S.D. Ireland Companies
Precast Division

Attention:	Ted Luck	Date:	6/2/2014
Company:	Luck Brothers	Job Name:	Warren BRF 013-4(32)
Address:		Job Number:	SDI #14046
City, St, Zip:		Regarding:	RFI #1
Ph: / Fax:

Notes/Remarks: Request for omission of rebar

STRUCTURE	VTAOT WARREN BRF 013-4(32) PRECAST
LOCATION	BRIDGE 166 ROUTE 100 (MINOR ARTERIAL) WARREN, VT
ARCHITECT	
ENGINEER	
CUSTOMER	S.D. IRELAND CONCRETE CONST. CORP.
DRAWN BY ED	DATE 2/18/14
DFI #	8756
DRAWING COVERS	ABUTMENT #1 DUAL COATED REINFORCING
DRAWING #	C

Drawing Sheet : C

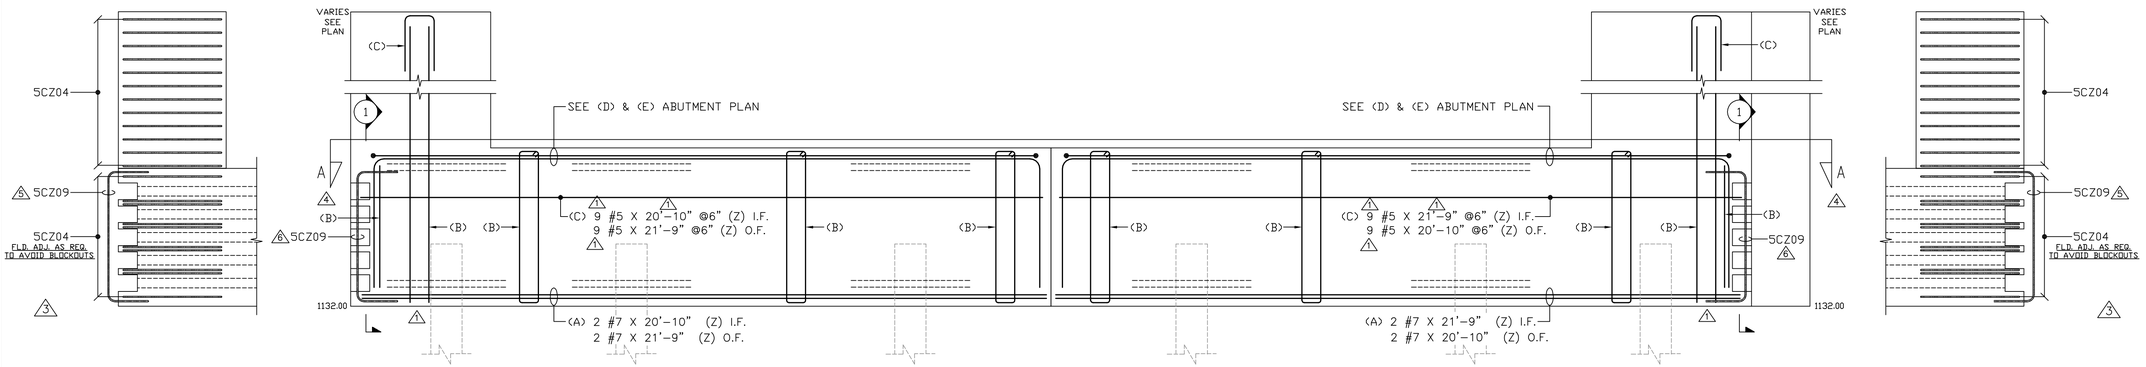
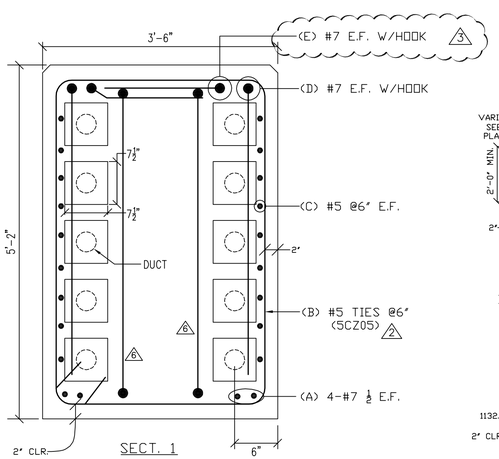
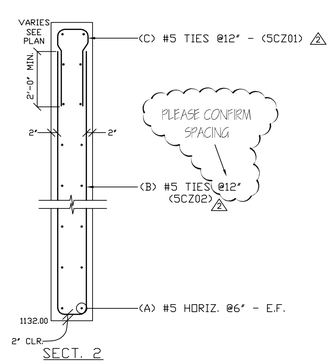
5CZ08	8	#5	6'-0"	1	0'-7"	4'-10"					0'-7"		0'-5"			
5CZ09	4	#5	10'-0"	17		2'-7"	4'-10"	2'-7"

Request to Eliminate

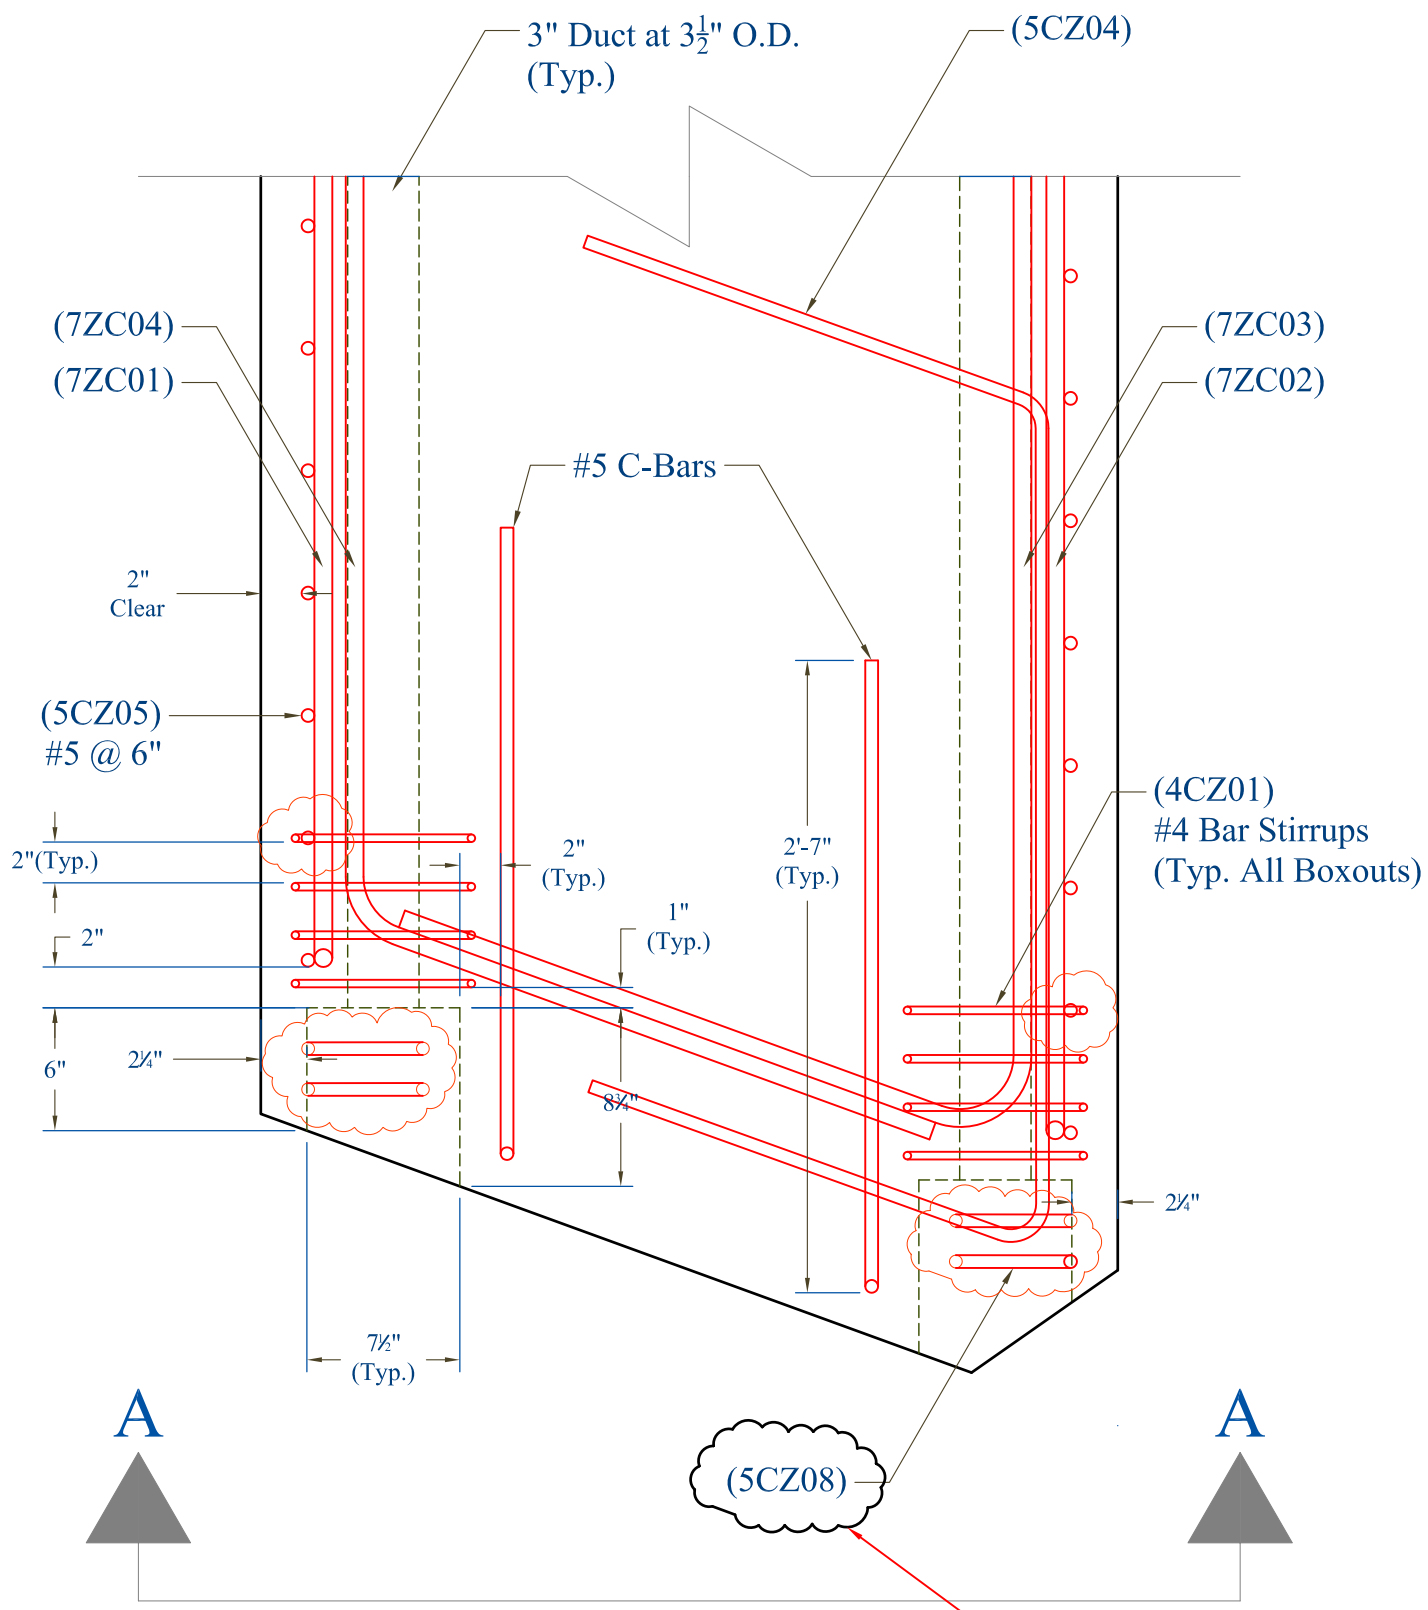
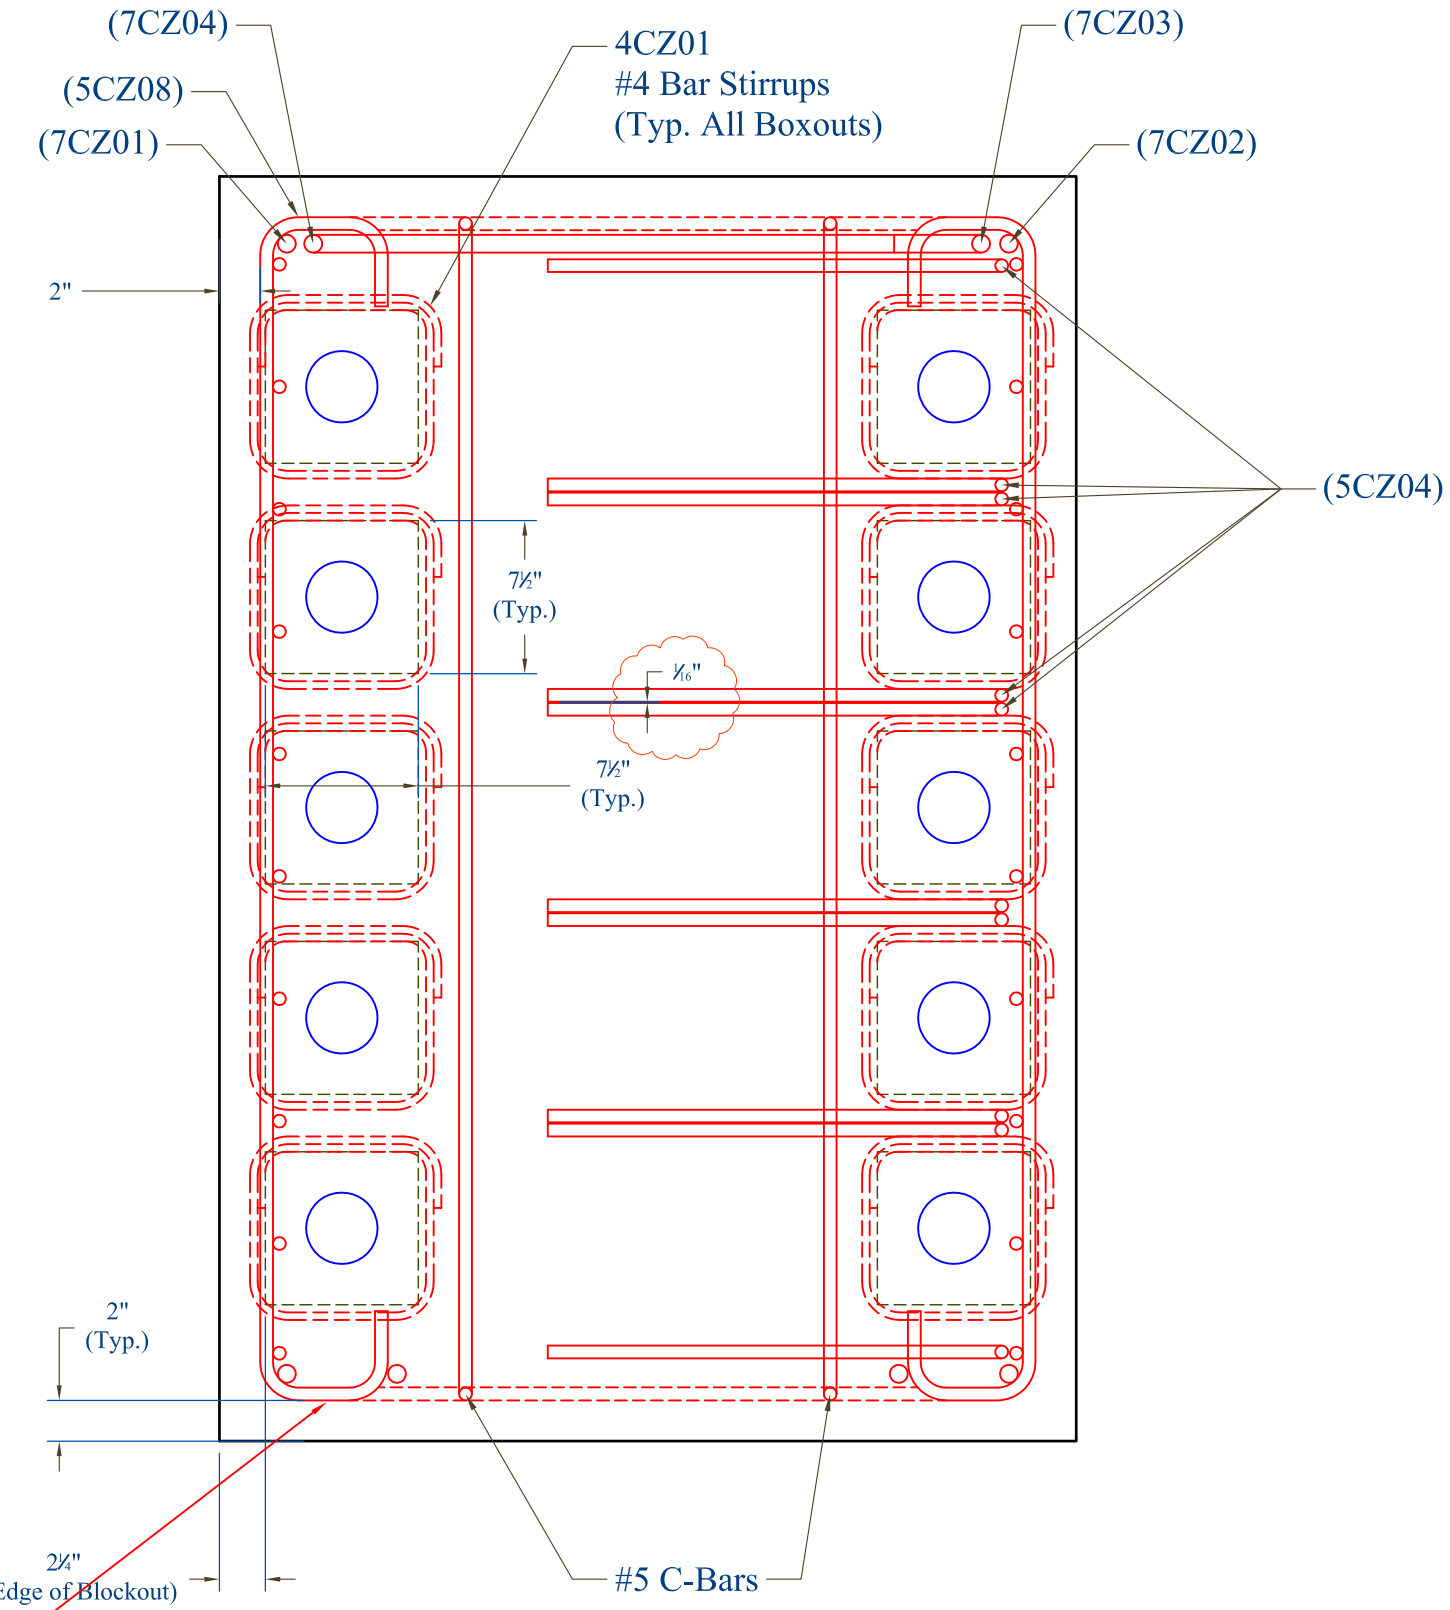
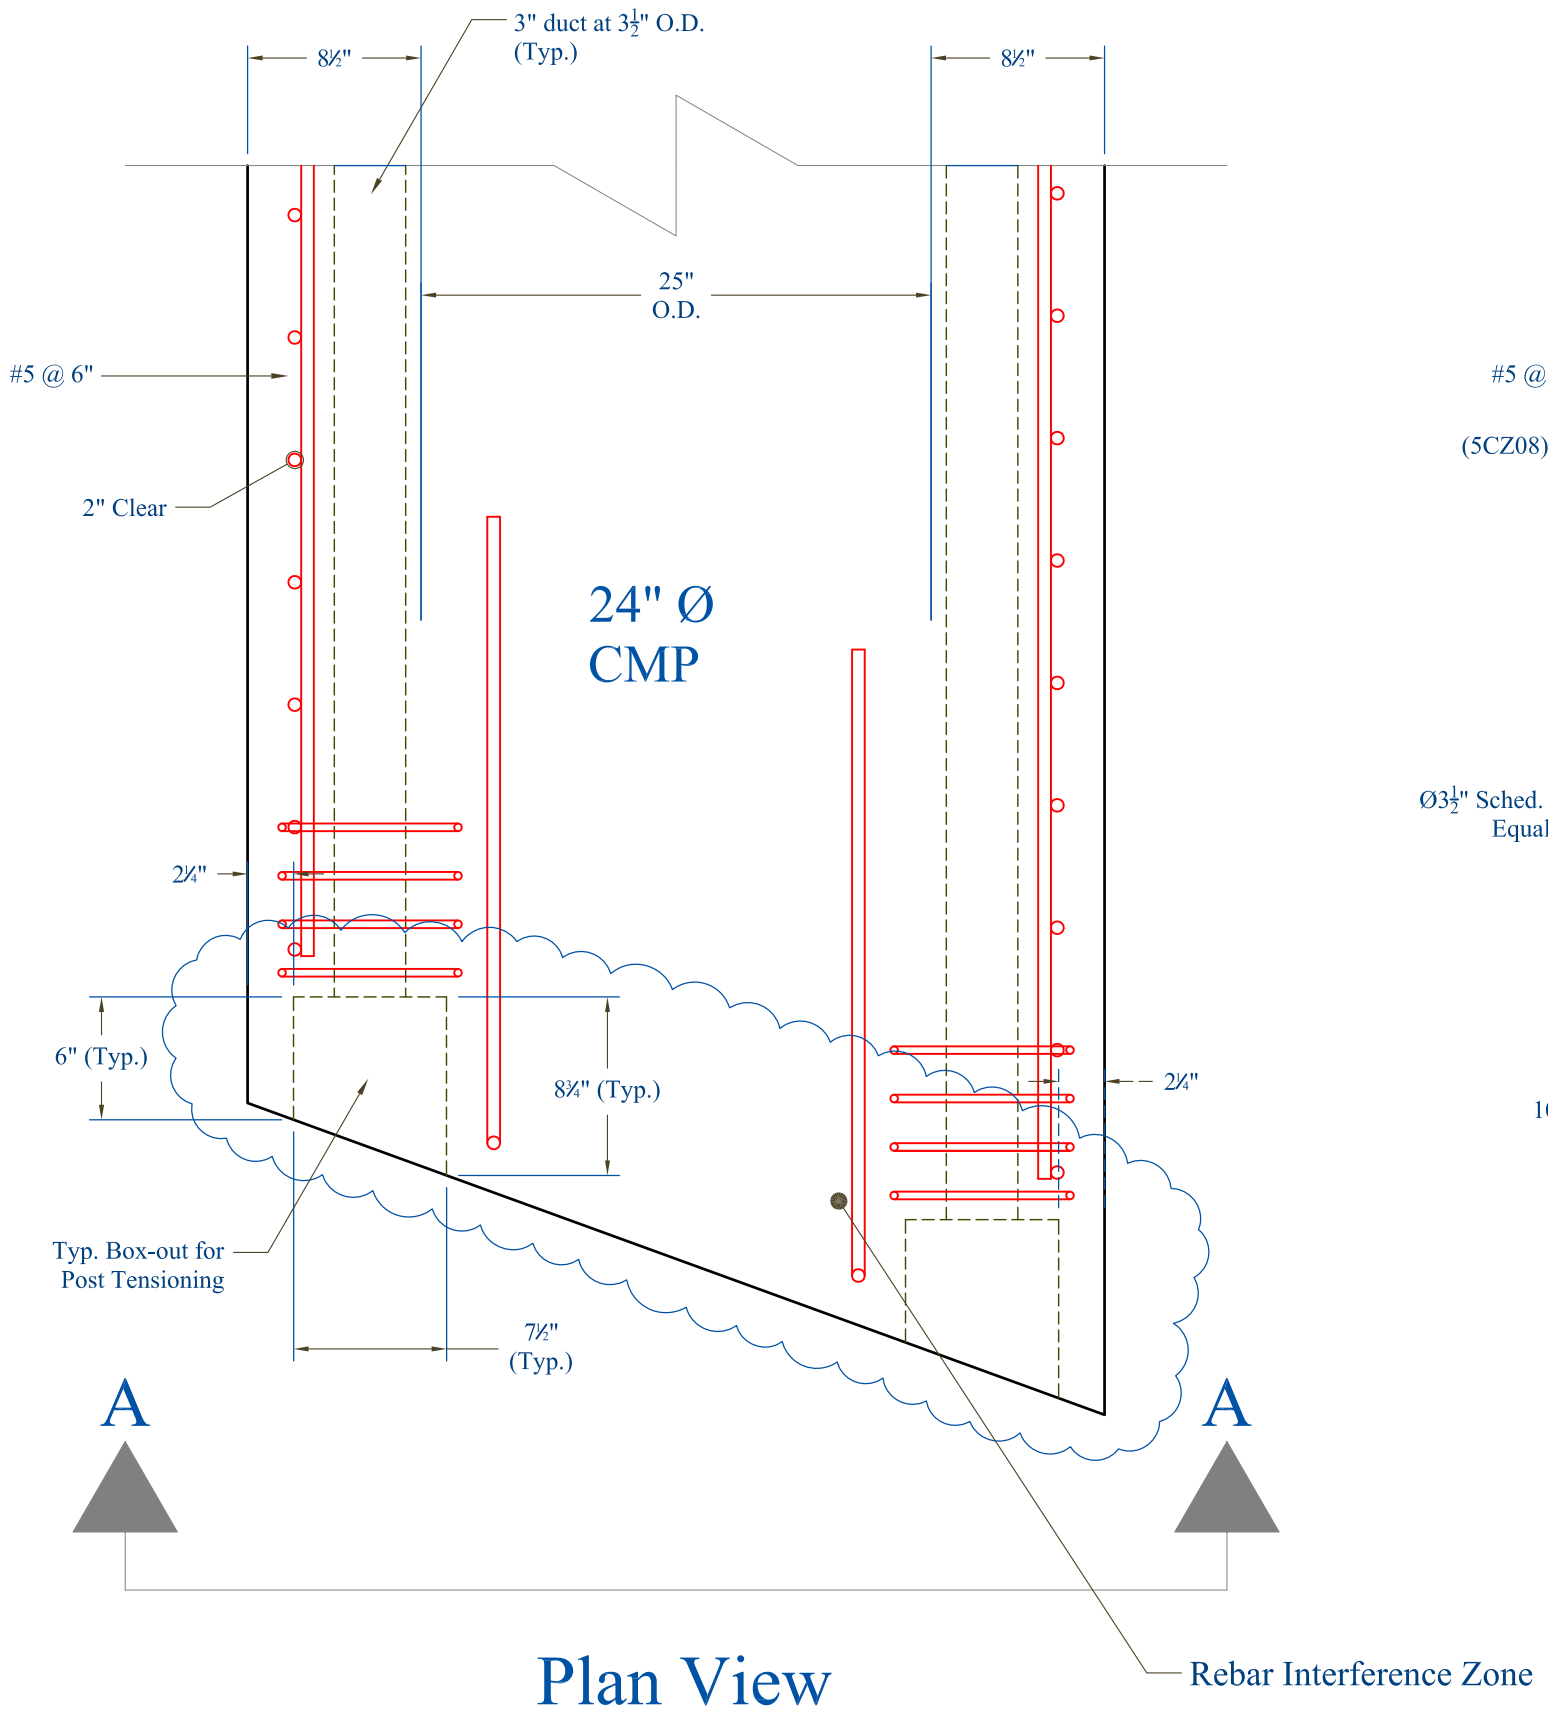
On the 17th of April our dual coated reinforcing supplier provided a reinforcing detail addressing the resolution of rebar 7CZ01, 02, 03, and 7CZ04, as suggested by MacFarland Johnson. See attached.
Our fabricator inadvertantly ADDED rebar 5CZ08. As focus was on the above change and acceptance this added rebar was overlooked. Attached
It is requested we be allowed to "eliminate" this interfering bar. This was bar not designed into the abutment to begin with.
